Access Compliance Report Public Rights-of-Way (Curb Ramps)

Main Street: PERDIDO_ST Cross Street: CHANTICLEER_RD Location: SW

ADA ID: RPRK210923113231 Ramp Type: Type 1 - Perpendicular Diagonal Initial Pass/Fail: Fail Overall Compliance: No Severity Score: 30

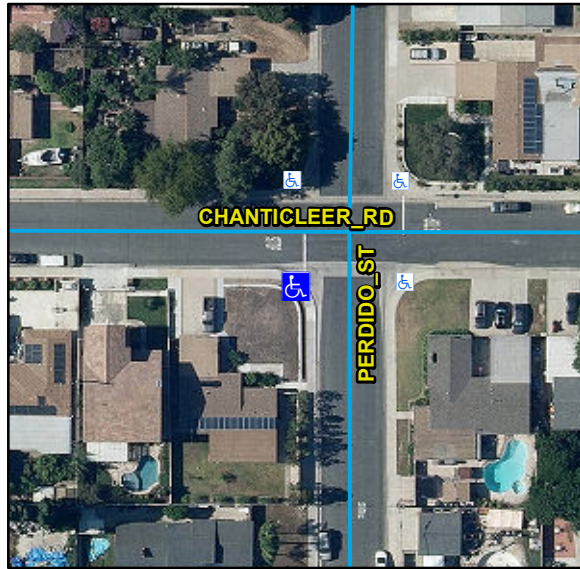
Remove & Replace Curb Ramp With Two New Directional Ramps or Equivalent. Grind Gutter Lip.

R204.3, R304.2.2, R302.7.2, STD 1115
